# Access Compliance Report

## Public Rights-of-Way

Intersection ID: 27363	Main Street: REA_RD	Cross Street: BALLANTYNE_COMMONS_PY	Location: NW
ADA ID: 320EB92EA2F1	Ramp Type: Perp	Initial Pass/Fail: Fail	Overall Compliance: No
Severity Score: 22.5			
Codes/Mitigation Info/Possible Solution		Field Measurements/Component Compliance

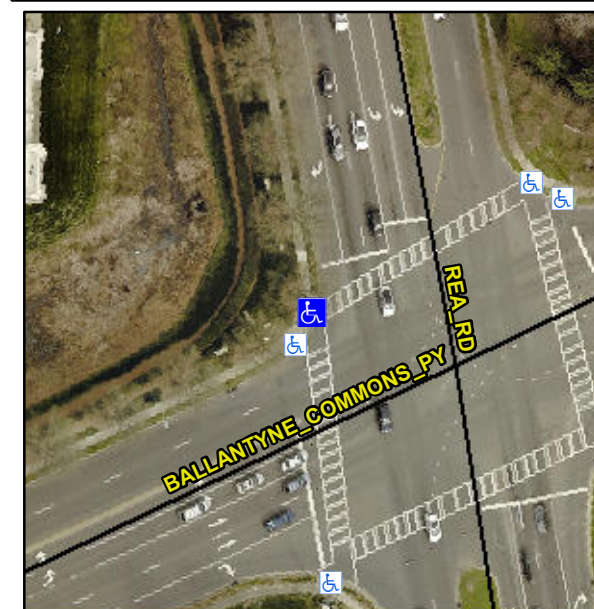
**Remove & Replace Entire Ramp.**

**R304.5.1, R304.2.2, R304.5.3**
